11 June 2025

Chief Executive Officer
Northern Beaches Council
PO Box 82
Manly NSW 1655

RE: OBJECTION TO DA2025/0536 – 19 BURNE AVENUE, DEE WHY
CONSTRUCTION OF A SECONDARY DWELLING AND
ALTERATIONS & ADDITIONS TO A DWELLING HOUSE

Figure 1: Extract from Survey of 19 Burne Avenue (Lot 2) submitted with DA, dated 29/11/21, prepared by Hill and Blume Consulting Surveyors

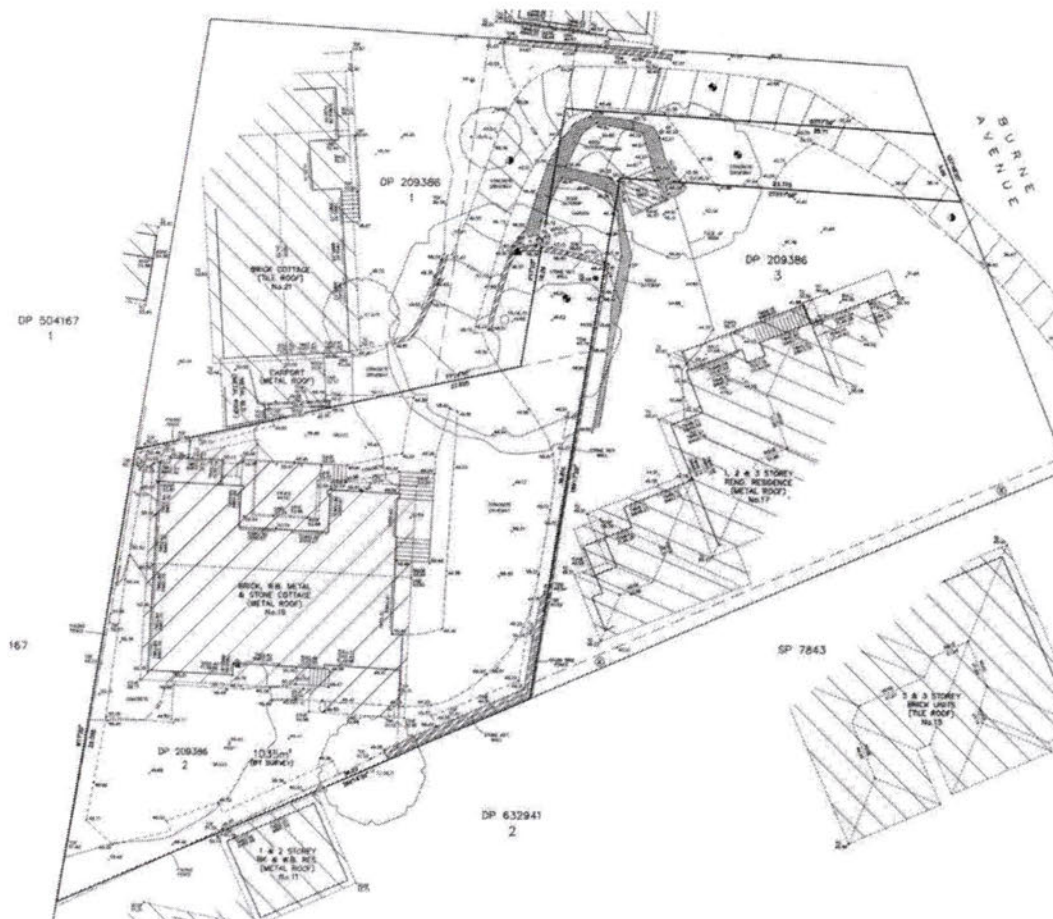
Vehicular and pedestrian access to the subject site is via an existing driveway which extends from Burne Avenue and traverses part of 17 Burne Avenue, the access handle of 19 Burne Avenue and the access handle and the main part of 21 Burne Avenue, as depicted below:

Figure 2: Extract from DP209386, showing the R.O.W. in the access handle of Lot 2

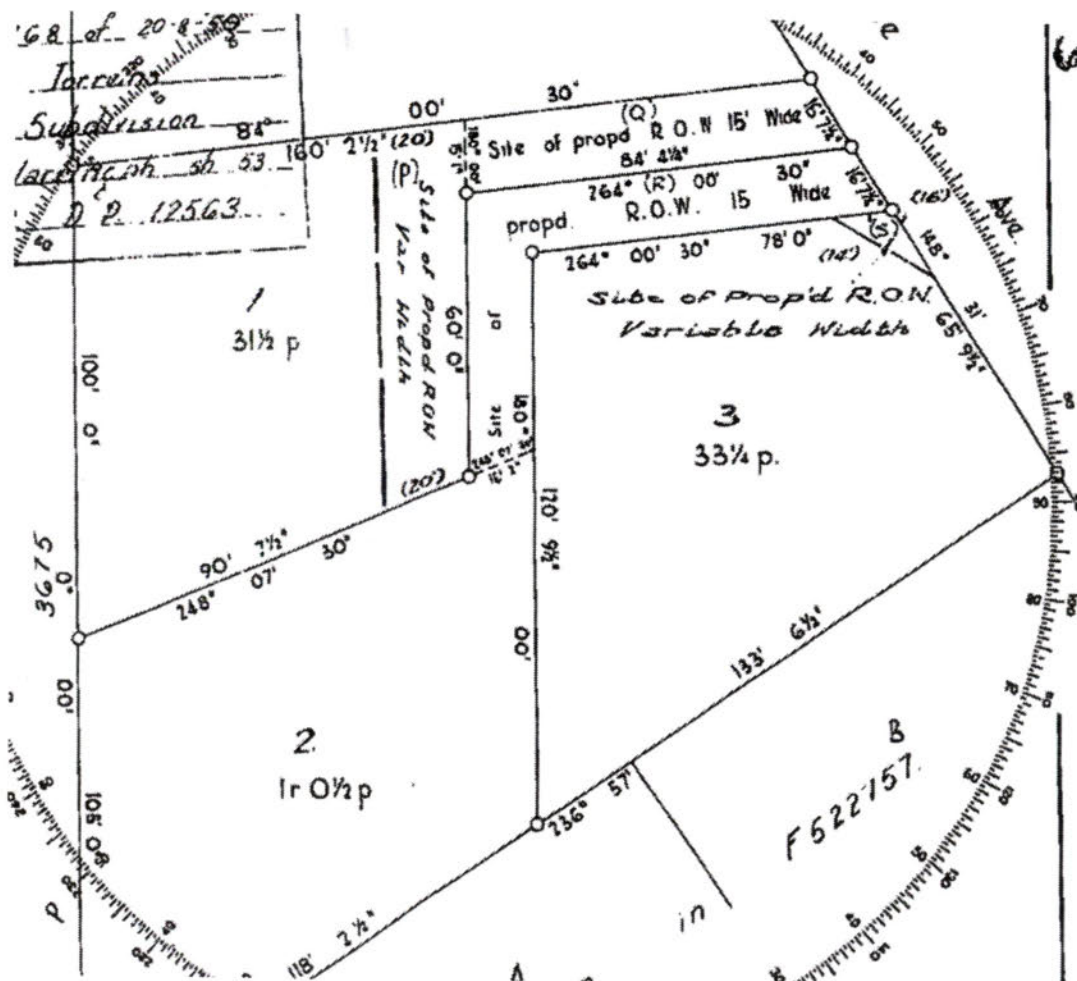
A significant and likely fatal issue with the proposed development is that the secondary dwelling is located on the access handle of 19 Burne Avenue, which would unlawfully interfere with the right to access this part of the site in accordance with the existing Right of Carriageway burdening Lot 2 and benefitting Lots 1 and 3. Any structure on the Right of Carriageway that would impede access to the Right of Carriageway by Lots 1 and 3 would be unlawful and contrary to the rights of the dominant tenement, in this case being Lots 1 and 3.

The proposed disregard of a registered easement on the title of the subject site and the consequent impact of impeding lawful access to the Right of Carriageway by Lots 1 and 3 is a valid matter for consideration under section 4.15(1)(b),(c),(d) and (e) of the Environmental Planning and Assessment Act 1979 (EPA Act). It is anticipated that Northern Beaches Council, as the consent authority, would not support a development that completely disregards the access rights conferred on Lots 1 and 3 by an existing Right of Carriageway.

Figure 3: Photographs of Tree 3, located on 21 Burne Avenue, Dee Why

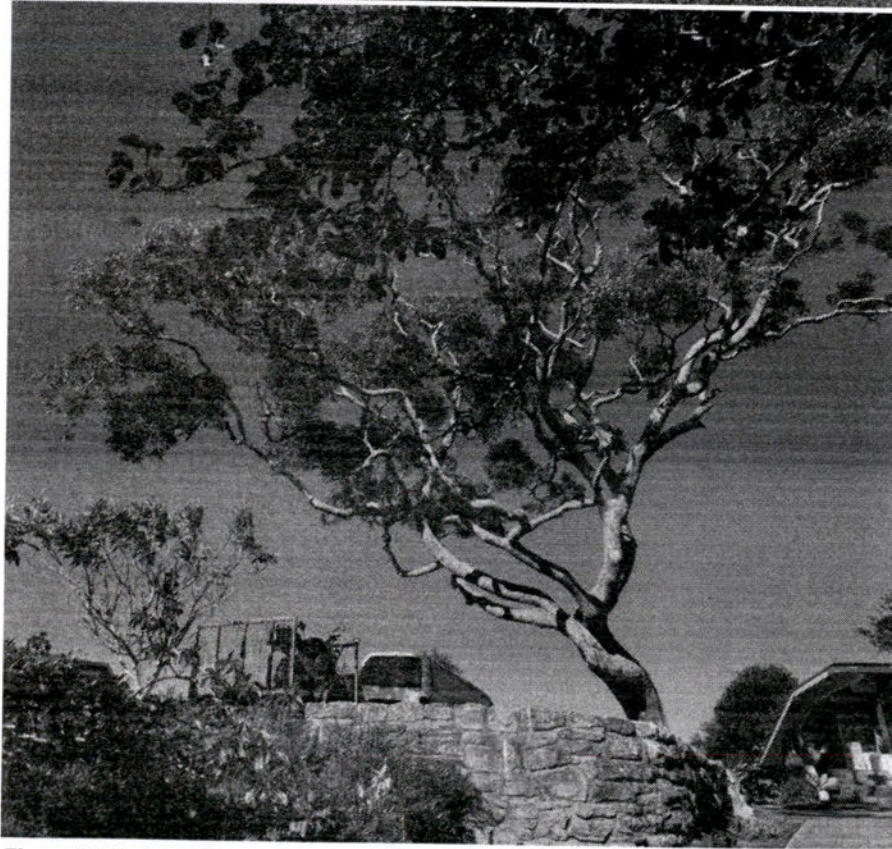
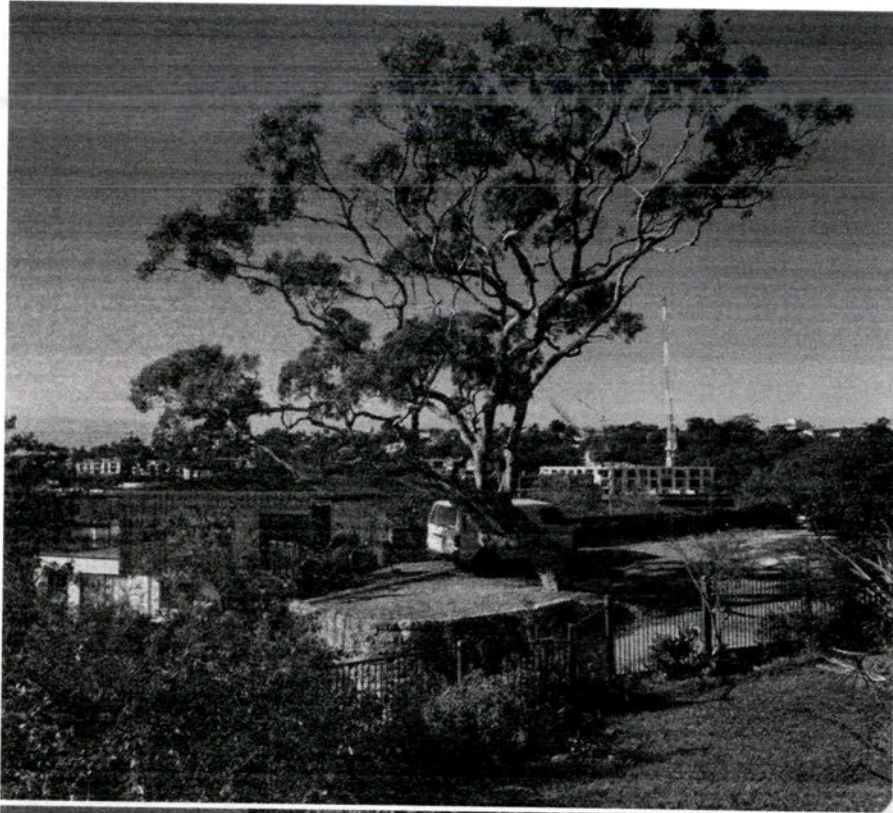
The subject tree is identified in the Arboricultural Impact Appraisal and Method Statement prepared by Naturally Trees, dated 15 May 2024 and submitted with the development application as Tree 3, being a mature *Angophora costata* with a height of 12m and a spread of 12m. The tree has no defects and is identified for removal presumably only due to being located within the proposed secondary dwelling envelope, with several limbs of the tree extending towards the east, from the main tree trunk.

In the absence of owners' consent from 21 Burne Street, Dee Why to the development application (being land to which the development application relates in terms of the removal of Tree 3 on 21 Burne Street), the development application has not been properly made. As owners consent is a precondition to the exercise of the power to grant development consent (including deferred commencement consent), a consent authority cannot grant consent to the proposed development, due to the absence of owners' consent.

In addition to the lack of owners' consent as discussed above, the subject tree is an outstanding specimen in excellent health, contributing significantly to the amenity of the area, and regardless of whether owners' consent is obtained, should not be removed to accommodate an inappropriate and poorly sited development.

Figure 4: East elevation of 21 Burne Avenue, Dee Why

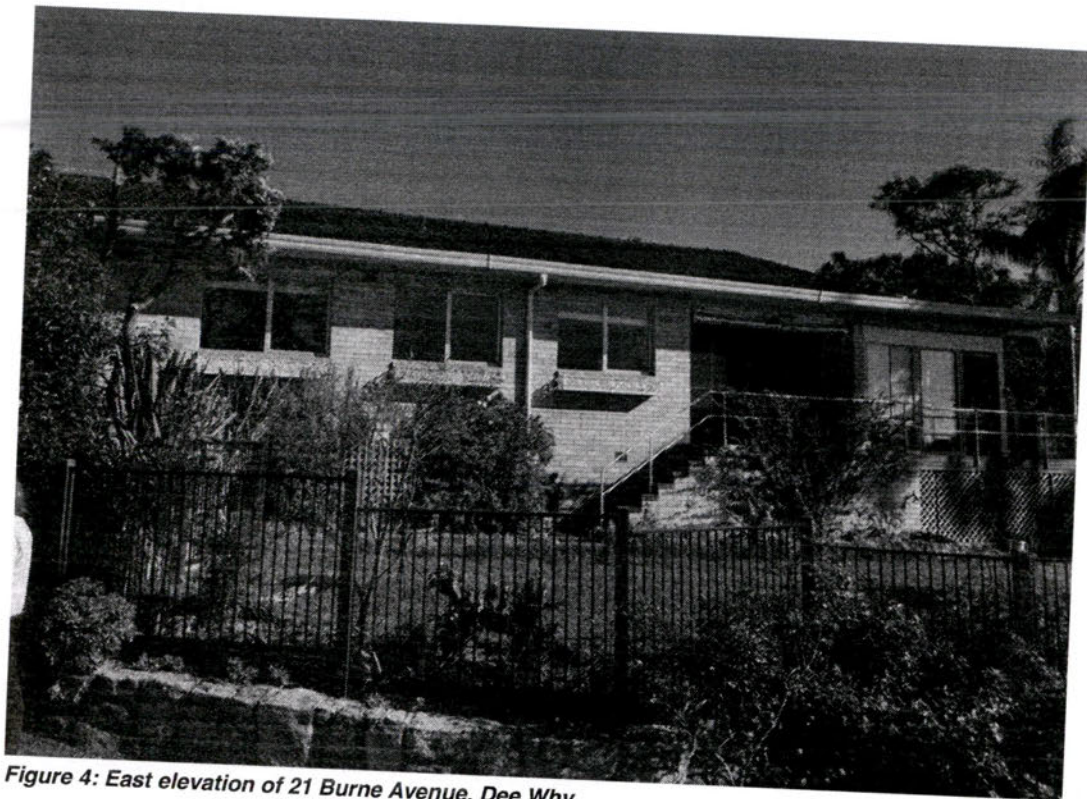
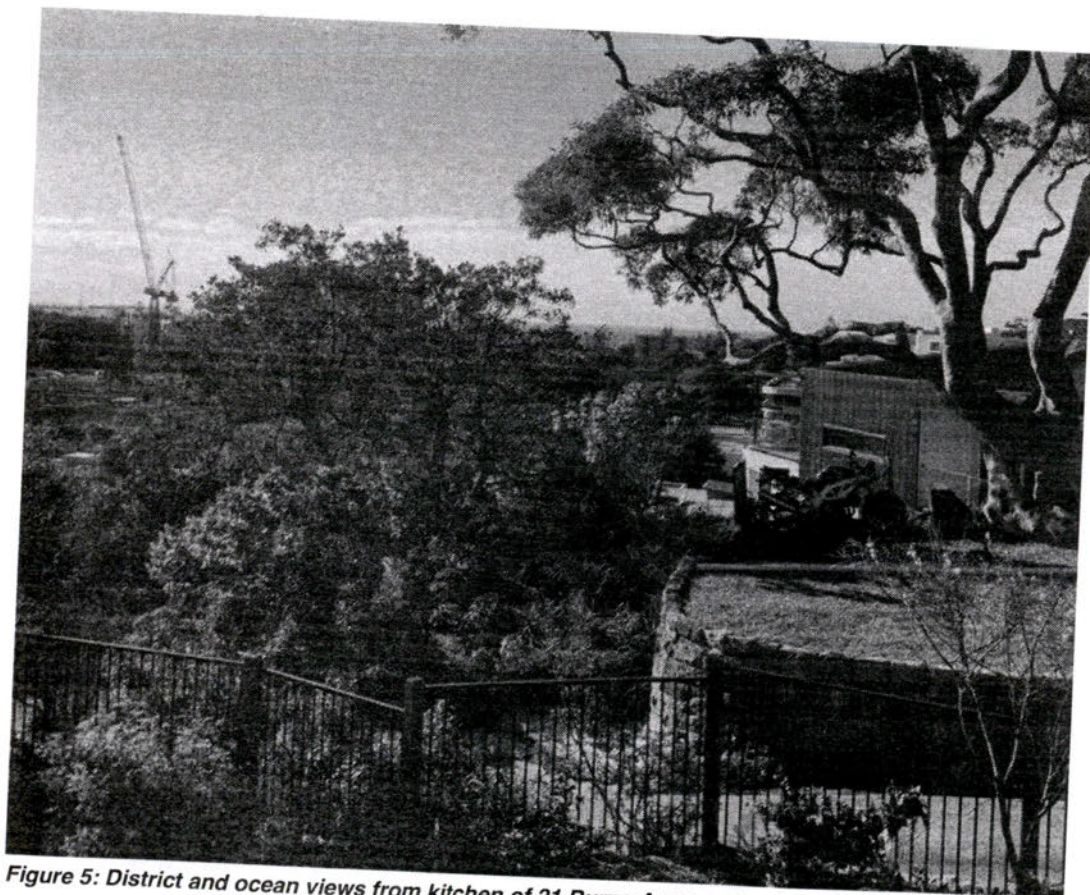
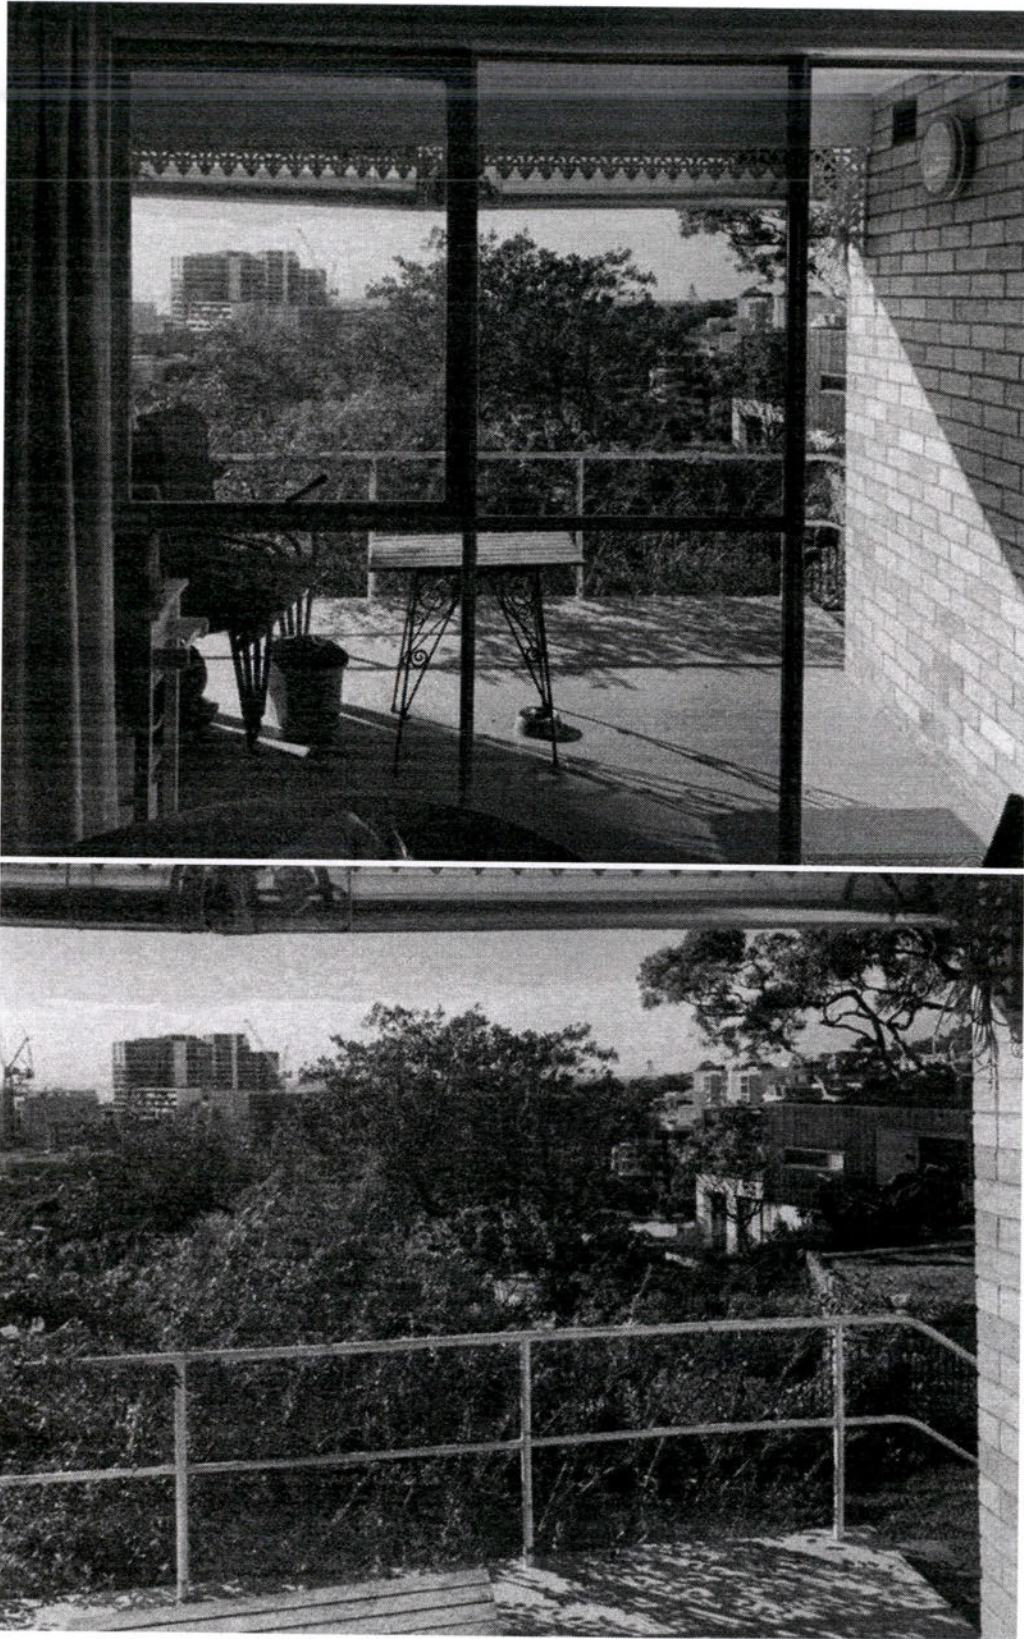
The proposed secondary dwelling would have a devastating impact on the ocean and district views currently available from 21 Burne Avenue, as a result of the secondary dwelling completely blocking all significant views to the east of the dwelling. The views that would be affected are obtained from a sitting room, dining room, living room, kitchen and balcony/terrace, in both a standing and sitting position. The eastern façade of 21 Burne Avenue has been designed to obtain and enjoy district and ocean views, with large windows to all rooms and an east-facing balcony:

In terms of the fourth step of the test set out in *Tenacity Consulting v Waringah* [2004] NSWLEC 140, the proposal is a completely unreasonable form of development that seeks to impede lawful access by Lots 1 and 3 to the Right of Carriageway on which the secondary dwelling is sited, and requires the removal of a tree on an adjoining site without owners' consent.

The proposal is simply not a reasonable form of development and as such, the proposed devastating view impact is unacceptable with regard to *Tenacity*.

Figure 7: Extract from plan DA-14, prepared by Romina Rojo Studio, showing the western façade of the proposed secondary dwelling

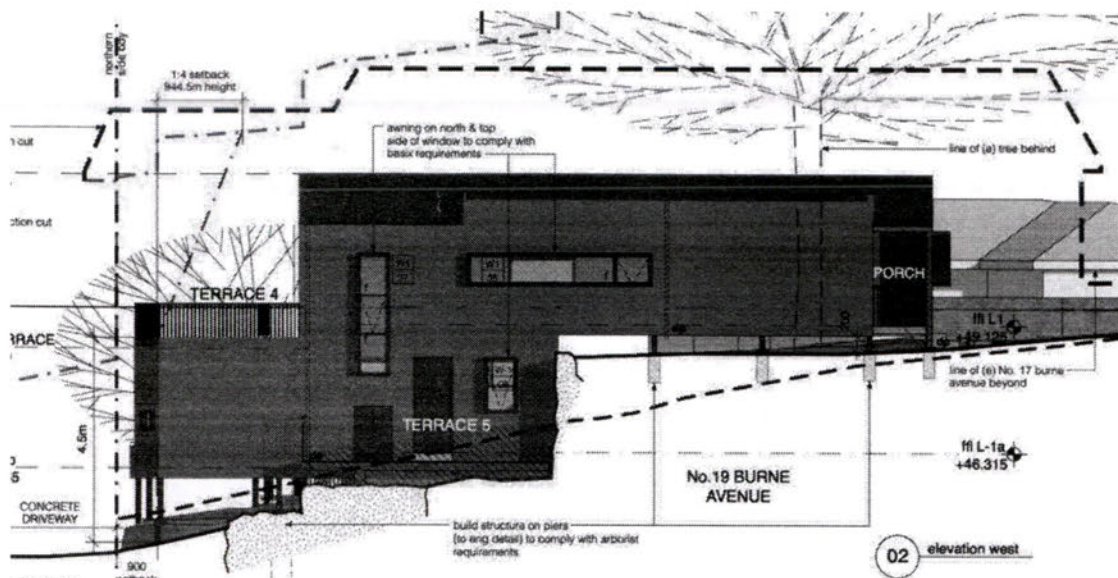
In relation to visual impact, the 14m long roof ridge of the proposed secondary dwelling (at RL52.45) would extend well above the ocean and headland horizon line currently visible from 21 Burne Avenue, and the western façade of the secondary dwelling would completely dominate the outlook from the east facing windows and balcony of 21 Burne Avenue, replacing views of mature trees and landscaping, the Dee Why town centre and the ocean beyond, with a largely blank façade, being part one and part two storeys in height, and an outdoor terrace (Terrace 4) which serves as the principal private open space of the secondary dwelling:

The proposed secondary dwelling does not represent good design and does not improve the urban environment, being an inappropriately sited dwelling with sub-standard internal amenity. Additionally, the secondary dwelling has an unacceptable adverse visual impact when viewed from the adjoining property at 21 Burne Avenue, Dee Why. The proposed height and scale of the secondary dwelling does not have sufficient regard for the site conditions and site constraints, proposing a dwelling within a battleaxe access handle.

In relation to 21 Burne Avenue, the secondary dwelling west facing windows and Terrace 4 would directly overlook the principal private open space, balcony and living areas of the dwelling, as can be seen in the west elevation in Figure 7 above.

Figure 8: Extract from plan DA-16, prepared by Romina Rojo Studio, showing the northern façade of the proposed secondary dwelling and in the background the proposed garage and Terrace 2 above (in relation to the main dwelling alterations and additions)

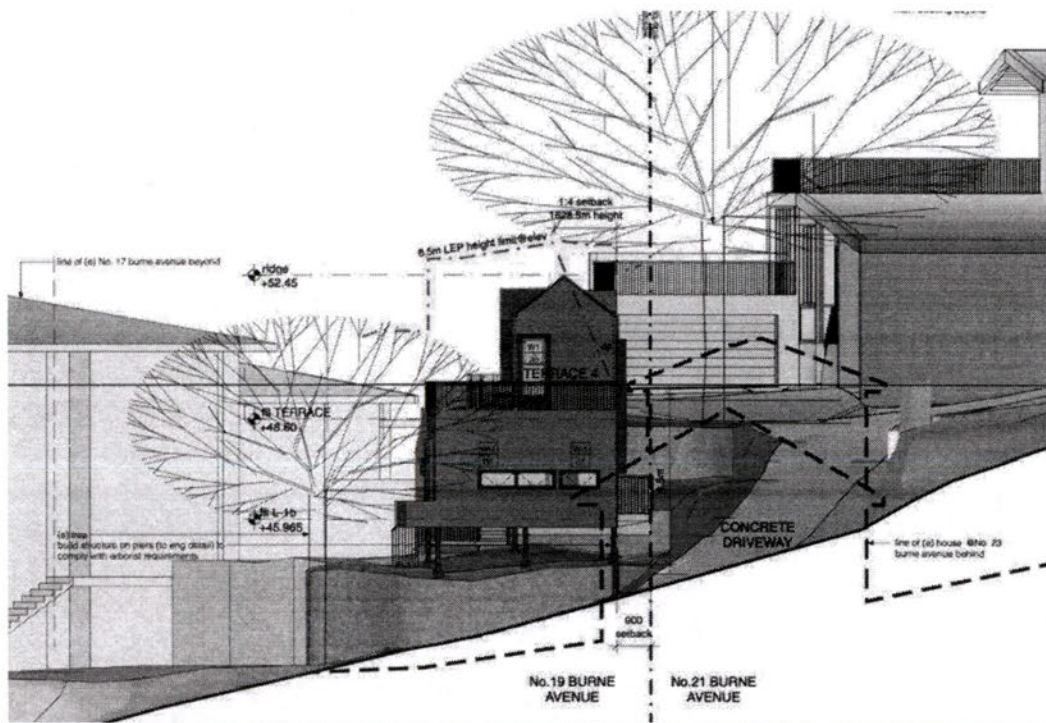
Additional overlooking impacts occur from Terrace 2 above the proposed garage, which is elevated by one storey, with an open balustrade to the eastern edge of the terrace, as can be seen on the east elevation (plan DA-08) and in the 3D rendering in Figure 9 below. The elevated nature of Terrace 2, together with the large area of the terrace (approximately 40m²) which adjoins a games room and the siting of the terrace directly opposite 17 Burne Avenue is likely to result in noise nuisance and disturbance

to 17 Burne Avenue. It is noted that there is an additional proposed terrace at Level 2, and that the Level 2 terrace (Terrace 3) is in fact larger than Terrace 2.

With regard to the above, Terrace 2 should be deleted or substantially reduced in area, with a significantly greater eastern boundary setback, in order to maintain aural and visual privacy to 17 Burne Avenue.
